**TOPOGRAPHIC SURVEY  
SEASPECT SHORT PLAT  
JOHN KAHAN**

PERMIT DRAWINGS  
 DATE: 06.10.22  
 SHEET SIZE: D (24X36)  
 REVISIONS

PROJECT TITLE:  
**Clarkson Residence**  
8163 West Mercer Way  
Mercer Island, WA 98040

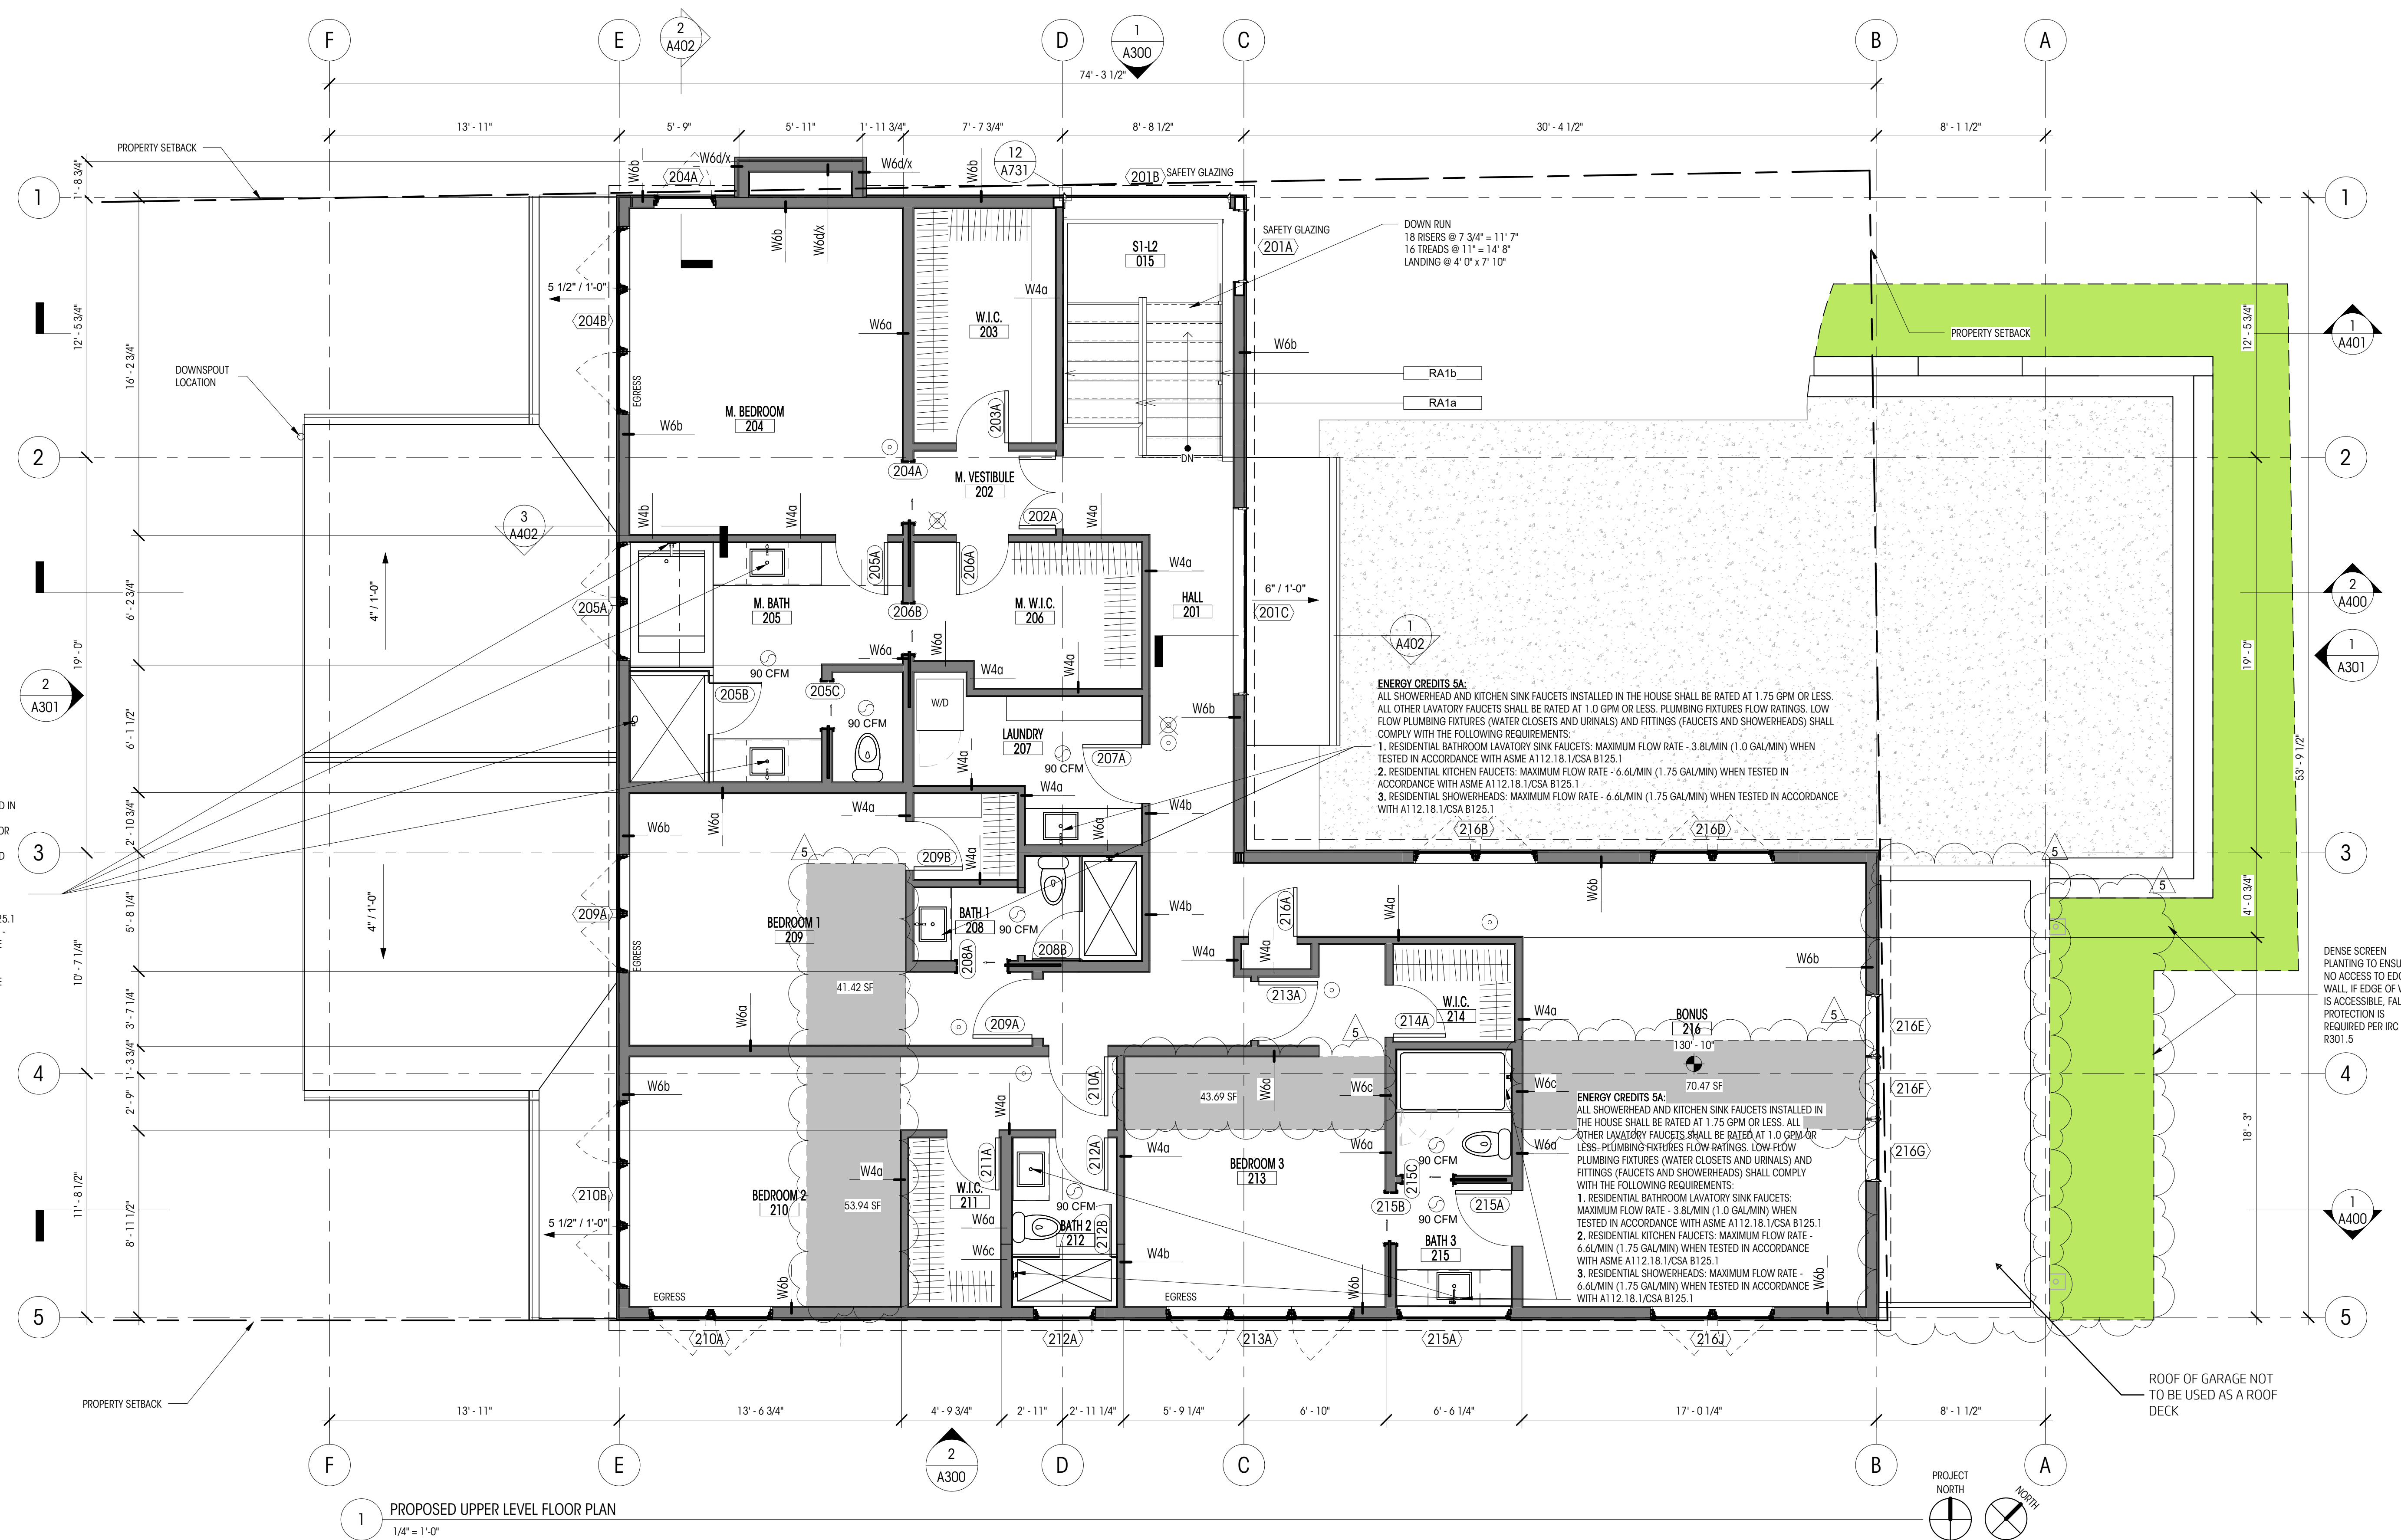
- INTERIOR LAYOUT CHANGES TO UPPER LEVEL.
- WINDOW SIZE & LOCATION CHANGES.
- EXTENDED WESTERN PATIO TO THE NORTH AND SOUTH.
- ELIMINATION OF UPPER LEVEL DECK, MAIN FLOOR DECK TO RECEIVE STANDARD GABLE ROOF.
- ADDED DORMERS AT UPPER LEVEL BONUS ROOM.
- OMISSION OF FIREPLACE AT UPPER LEVEL.
- SHIFT OF PARKING RETAINING WALLS TO NORTH AND SOUTH.
- ADDITION OF AWNING ROOFS OVER OFFICE & LIVING ROOM.
- EXTEND GARAGE EAST INTO FRONT YARD SETBACK AS ALLOWED BY CODE 19.02.040.D
- ADDED DECK AT ROOF OF THE EXTENDED GARAGE AREA.
- BATHROOM REVISIONS RESULT IN 1 ADDITIONAL TOILET AND 1 ADDITIONAL SHOWER

1 PROPOSED ROOF PLAN  
1/4" = 1'-0"

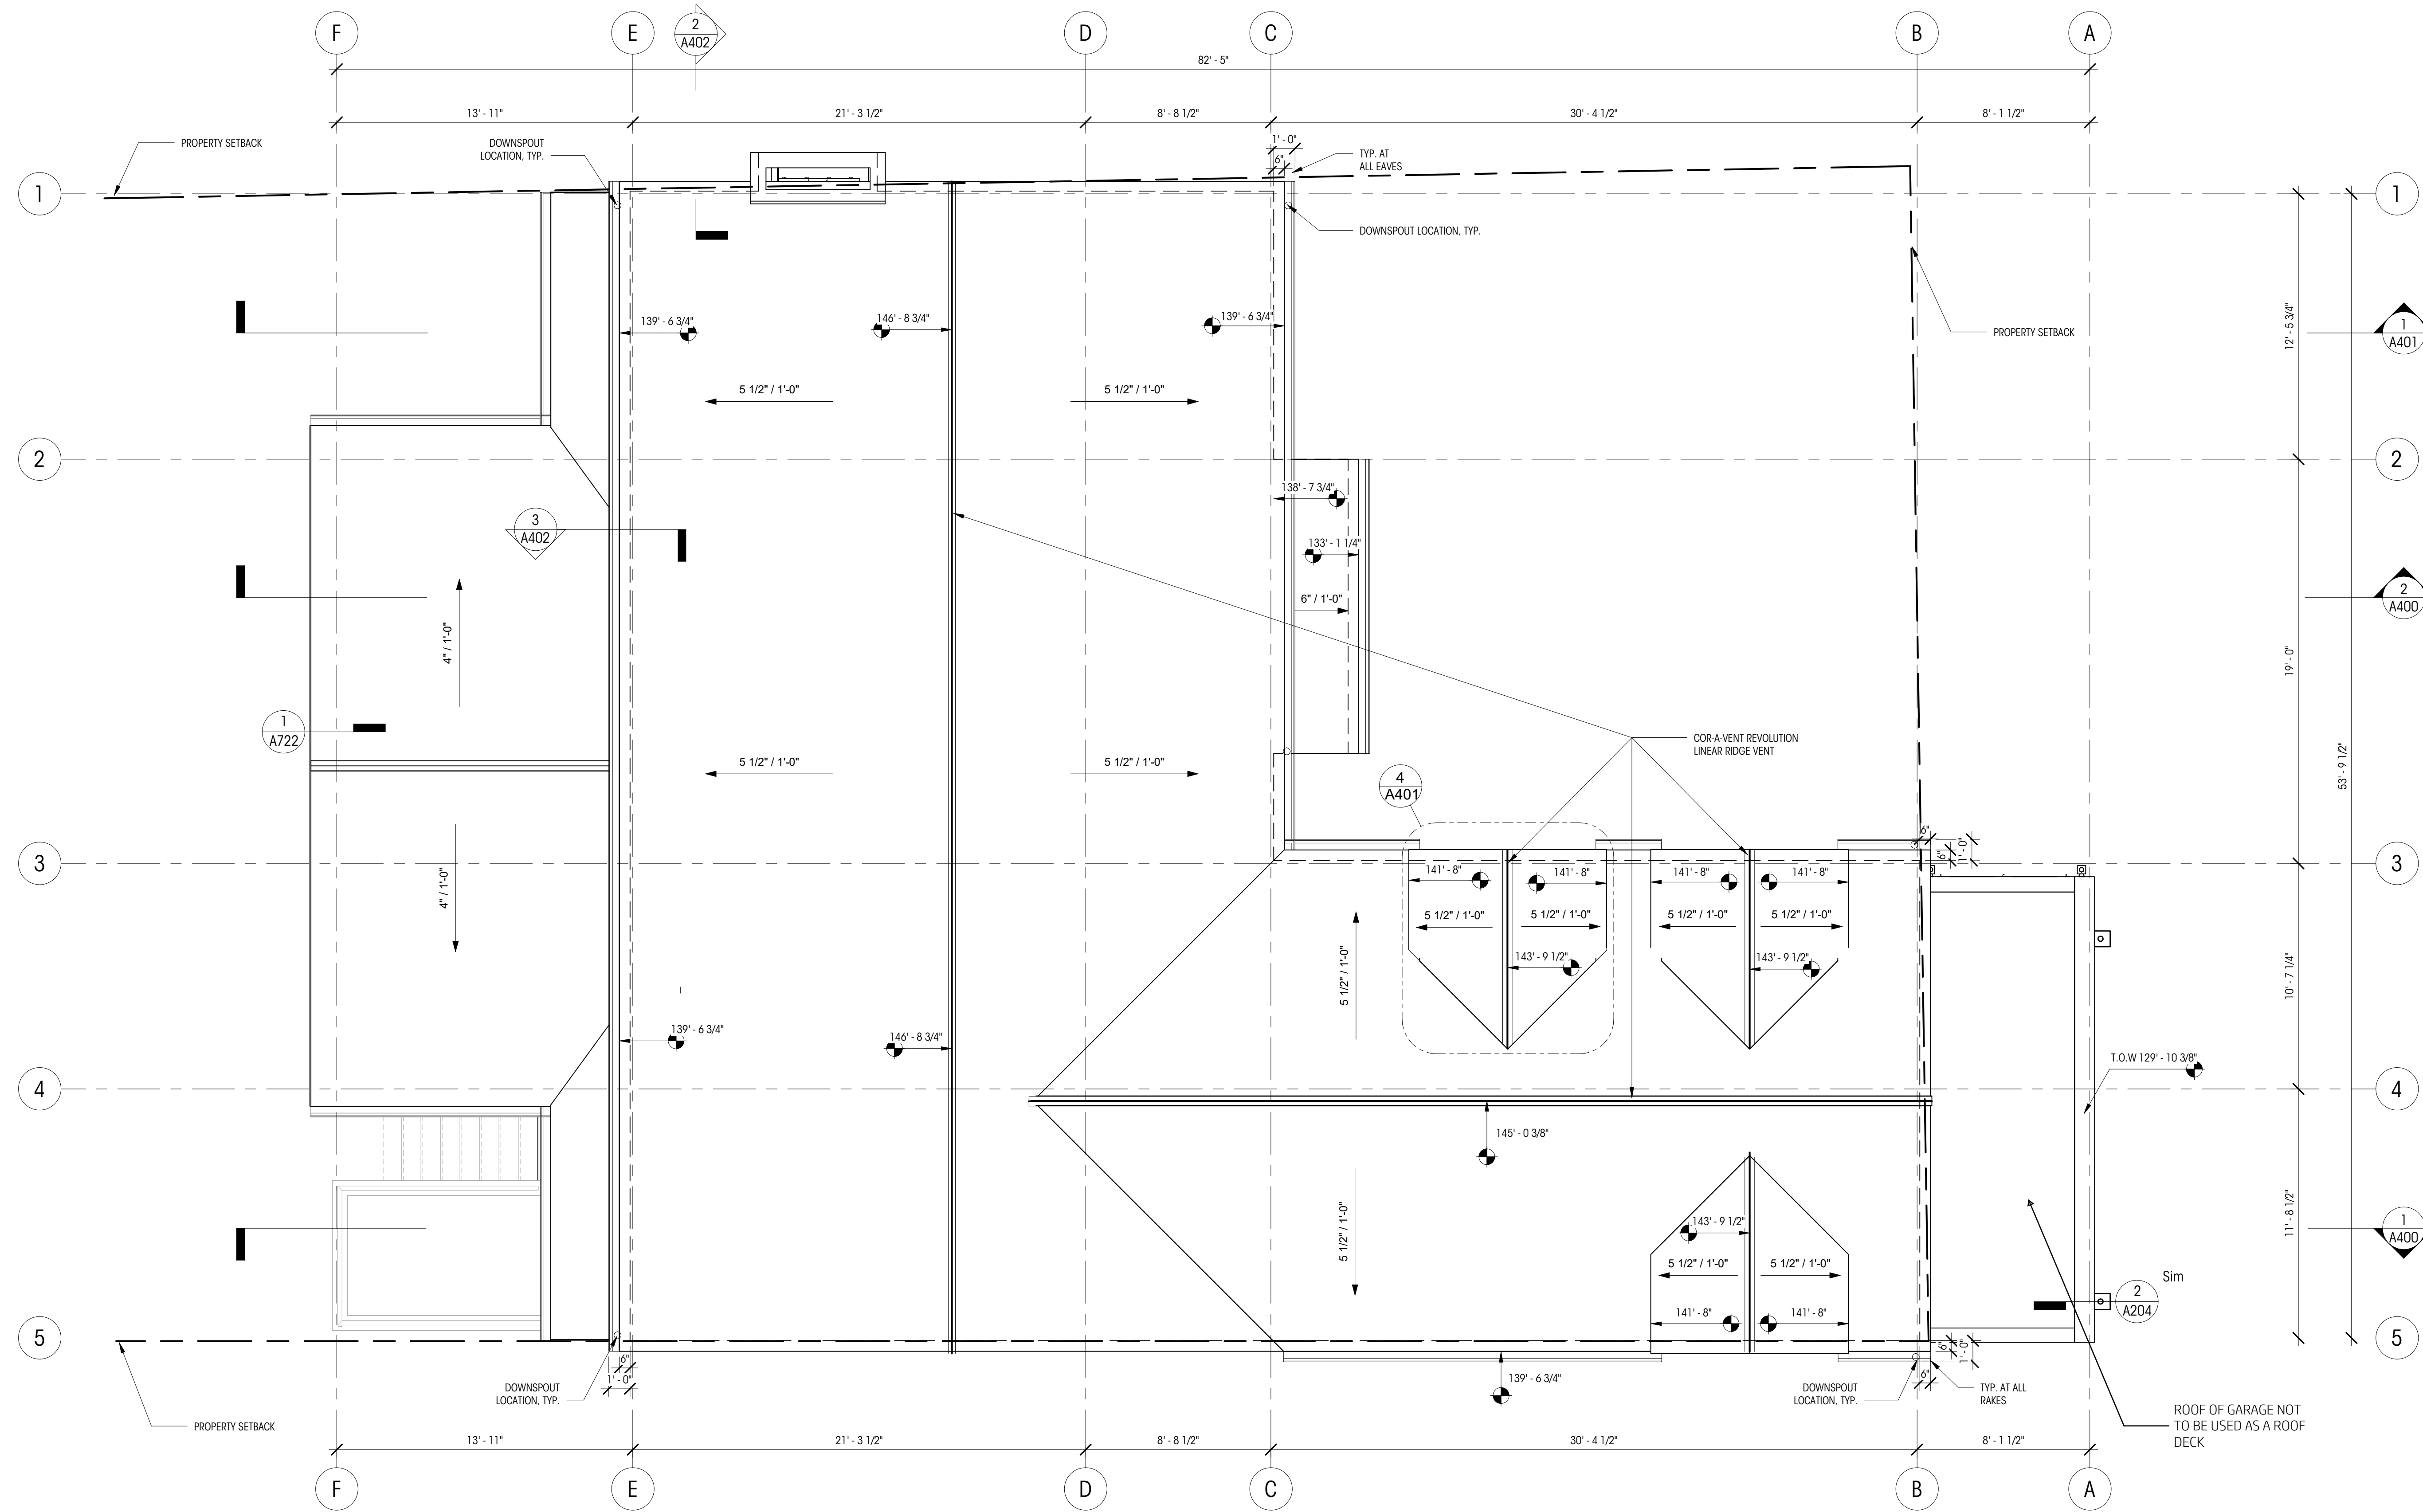
- CHANGE ROOF OF AND EXTEND WESTERN PATIO TO THE WEST AND SOUTH
- ADDED DORMERS AT UPPER LEVEL BONUS ROOM
- ADDED DECK AT ROOF OF THE EXTENDED GARAGE AREA.
- ADDED DETAIL FOR EXTENDED DECK DRAINAGE
- UPDATED ROOF VENTING CALCS AS A RESULT OF DORMER ADDITION
- REDUCED ROOF PITCH FROM 6:12 TO 5.5:12.
